ECE/TRANS/WP.29/GRRF/2009/31
3 July 2009

REGULATION No. 90
(Replacement brake linings)

Proposal for amendments to Regulation No. 90

Submitted by the expert from the European Association of Automotive Suppliers */

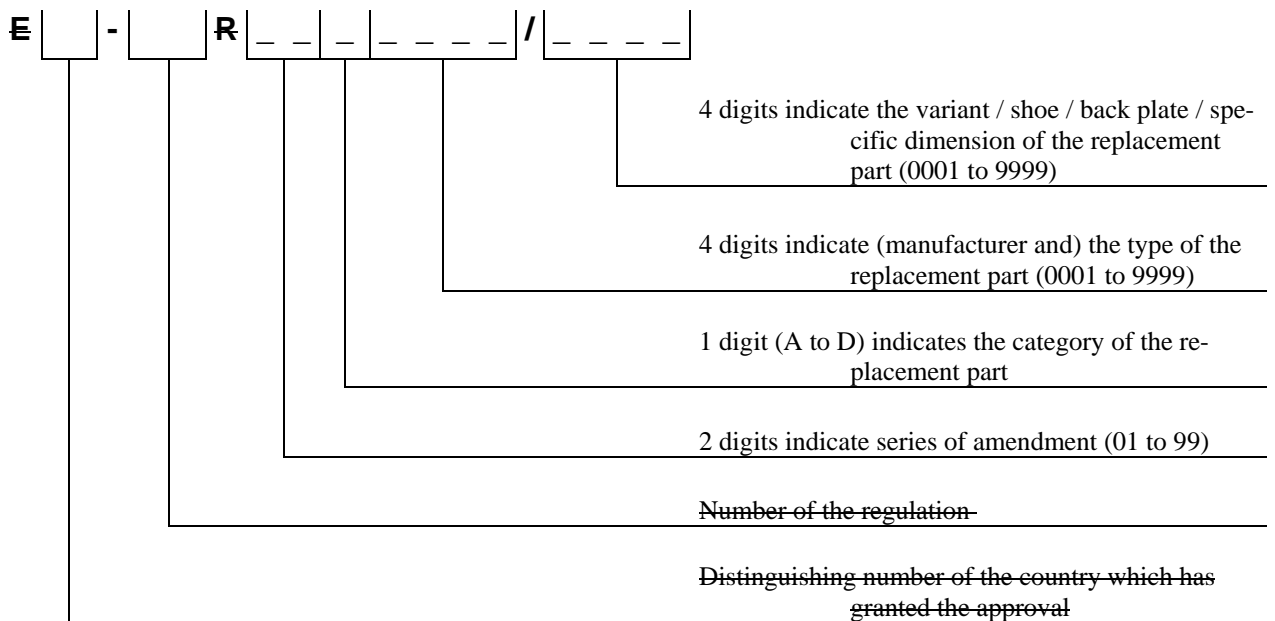
Annex 2, the existing approval mark and its explanatory text, amend to read:

"(See paragraph 4.2. of this Regulation)

a = 8 mm min.

The above approval mark shows that the item concerned has been approved in France (E₂) pursuant to Regulation No. 90 under approval number C0359/7248. The first two digits of the approval number indicate that the approval was granted in accordance with the requirements of Regulation No. 90 ~~in its original form~~ **as amended by the 02 series of amendments.**"

Annex 2, delete the last words of the last sentence to remain consistent with the marking example.

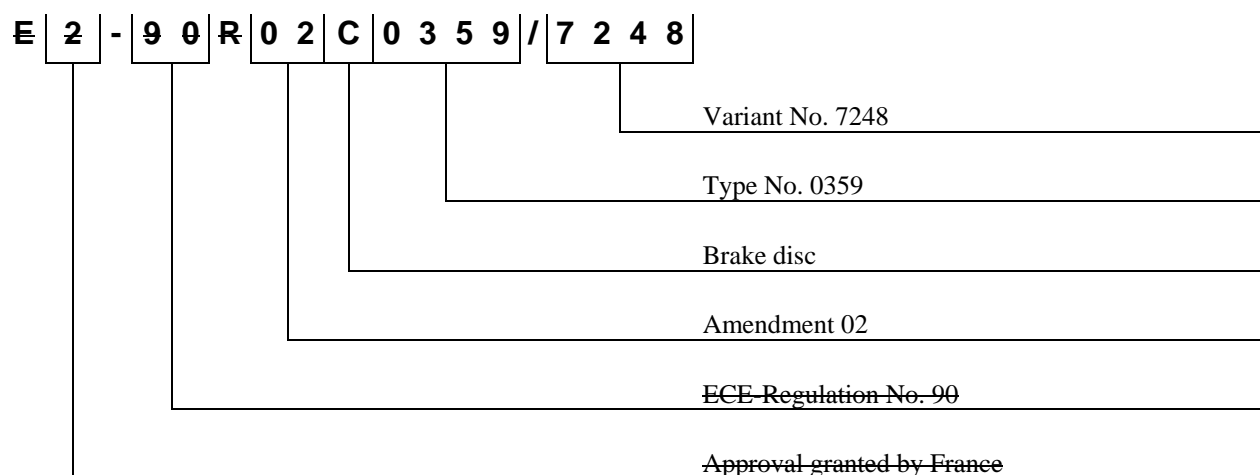
New paragraph 4.2.3., amend to read:

"4.2.3. The next four digits shall indicate the manufacture and the type of the brake lining, the type of disc or the type of drum.

A suffix of four digits shall indicate

- (a) the shoe or back plate or specific dimension in the case of drum brake linings,
- (b) the variant in the case of a replacement disc or replacement drum

Paragraph 4.2.3.: The examples are amended to avoid confusion because paragraph 4.2. addresses the type approval number and not the type approval mark which is addressed in paragraph 4.5.
